DESIGN REVIEW BOARD MAY 18, 2018

1. 09:00-09:30 North Point Eco District presentation and City Attorney briefing
2. 09:30 - 10:00 DRB180018 North Point Market Center 6110 North Point Pkwy
review elevations and landscape
3. 10:00 - 10:30 DRB 180021 Phase Office and Hotel Webb Bridge @ Morris
review elevations and landscape
4. 10:30 - 10:50 DRB 180012 Village Park at Wills
review landscape and lighting
5. 10:50 - 11:00 DRB180029 Thrive 44 Milton Ave
review signage
6. 11:00 - 11:20 DRB 180037 2B Whole Bakery 42 Milton Ave
review new exterior
7. 11:20 - 11:50 DRB 180035 The Cooler 10800 Davis Dr
review expansion
8. 11:50 - 12:30 DRB180036 Northwinds Summit Building B
review new construction

DESIGN REVIEW BOARD SUMMARY APRIL 20, 2018

LANDSCAPE PLANTING PLAN
SCALE 1" = 20'

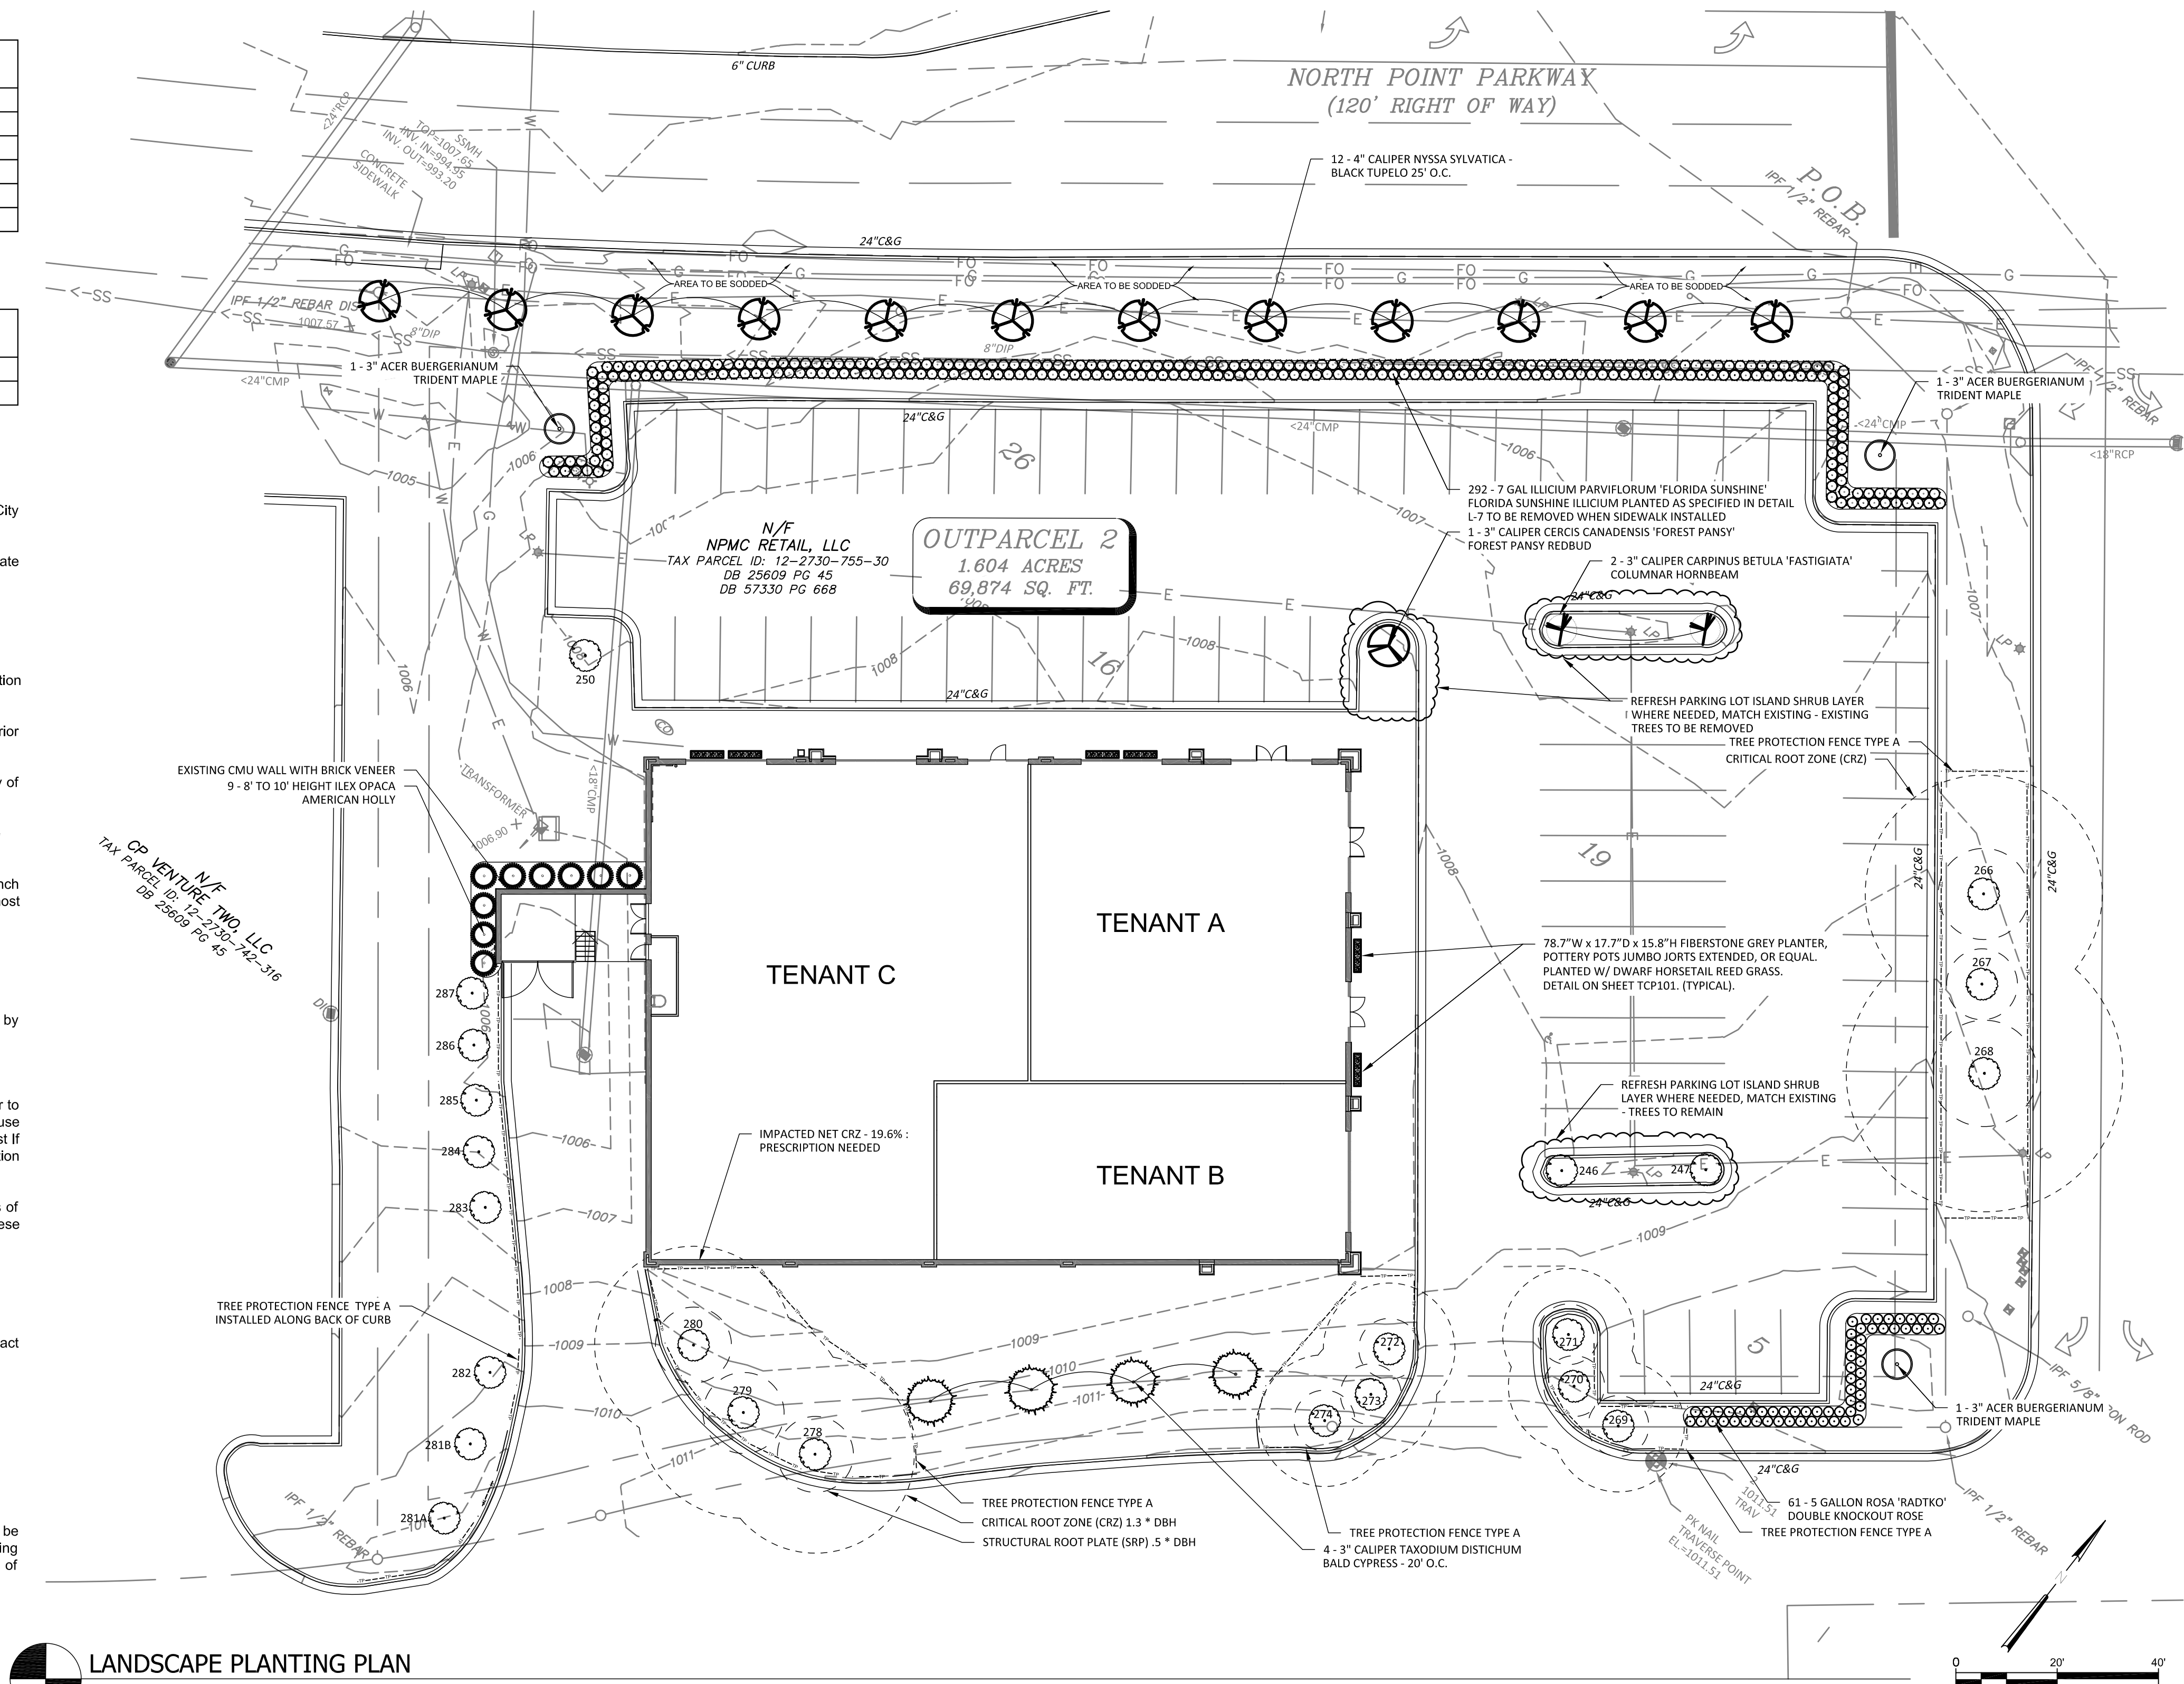
DESIGN REVIEW BOARD COMMENTS:

- They asked for additional planter & plants at sidewalk round the building and at MOD Piazza patio area.
- They requested 1-2 additional trees at the MOD Piazza patio
- Layout of trees along North Point Parkway to be presented as part of the DRB Review scheduled for 3/1/18 submission. The future sidewalk needs to be planned 10ft wide and next to curb on parking lot side. The new trees will be located adjacent and along North Point Parkway. The City is not requesting for the sidewalk to be put in place at this time, but for the trees to be planted accordingly to meet their design guidelines. They requested two rows of shrubbery along the parking lot side. When sidewalk is added, the shrubbery will be removed.
- Plants in front of the wood fence with dumpster
- Review Island Landscape, and existing trees meeting code.

LANDSCAPE PLANTING PLAN SCALE 1" = 20'

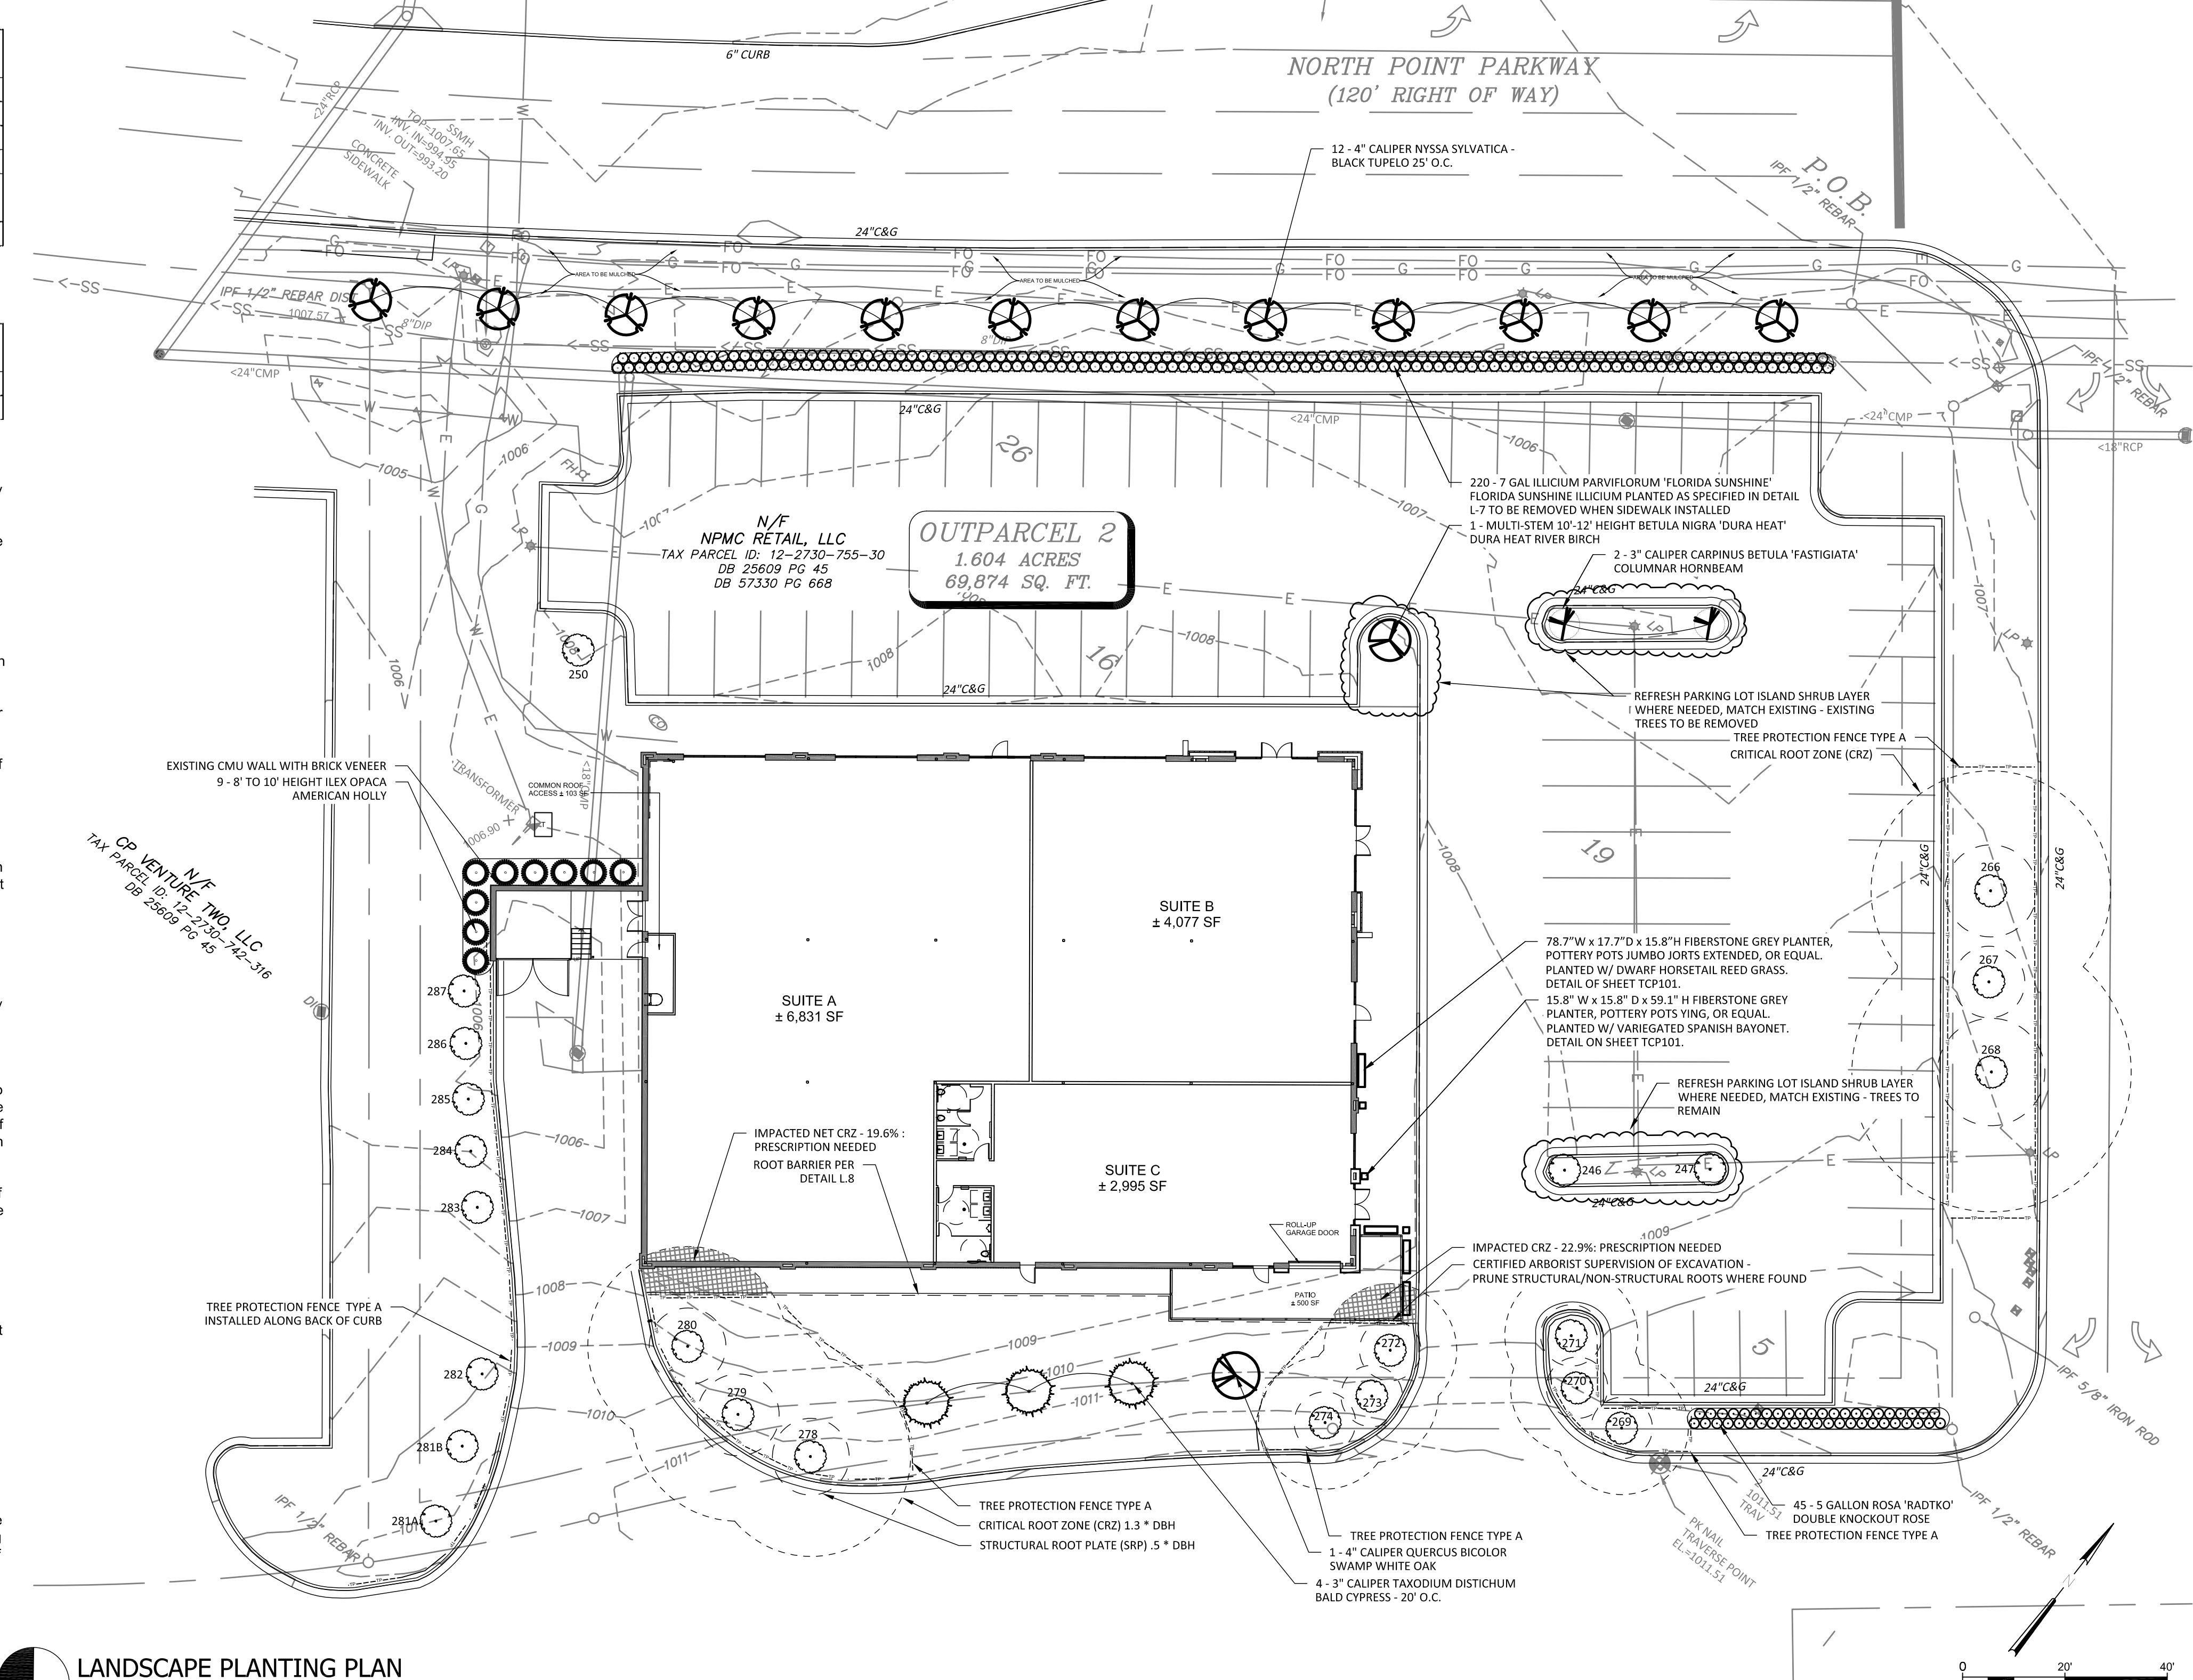
- They asked for additional planter & plants at sidewalk round the building and at MOD Pizza patio area.
- They requested 1-2 additional trees at the MOD Pizza patio
- Layout of trees along North Point Parkway to be presented as part of the DRB Review scheduled for 3/1/18 submission. The future sidewalk needs to be planned 10ft wide and next to curb on parking lot side. The new trees will be located adjacent and along North Point Parkway. The City is not requesting for the sidewalk to be put in place at this time, but for the trees to be planted accordingly to meet their design guidelines. They requested two rows of shrubbery along the parking lot side. When sidewalk is added, the shrubbery will be removed.
- Plants in front of the wood fence with dumpster
- Review Island Landscape, and existing trees meeting code.
